Comments on 07-339r2

SAS-2 Phy Electrical Specification

K. Witt 15 August 2007 07-336r0

5.3.5.2 Transmitter Device Eye Mask

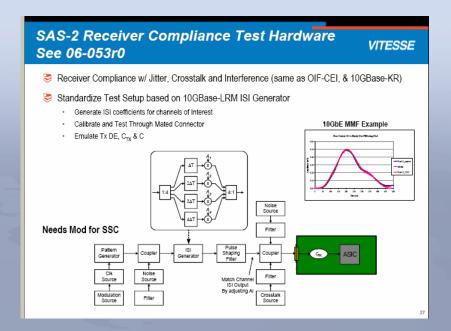
I assume the intent is to specify that we are testing the Tx Compliance through a Ref Channel and Ref Rx.

Issues:

- 1) Need to define methodology completely.
 - For example are we capturing the Tx waveform w/ a specific data pattern CJTPAT and then processing?
 - If so, do we measure RJ and use in the simulation?
- 2) Crosstalk "with reverse traffic"
 - In simulation we will need to define:
 - The coupling channels (s-parameters)
 - Number of Aggressors
 - Amplitude of Aggressors / rise time / De-Emphasis
 - Frequency and phase relation-ship of Aggressors and primary Channel.

Proposed Change:

Full define what is collected and how it is processed.
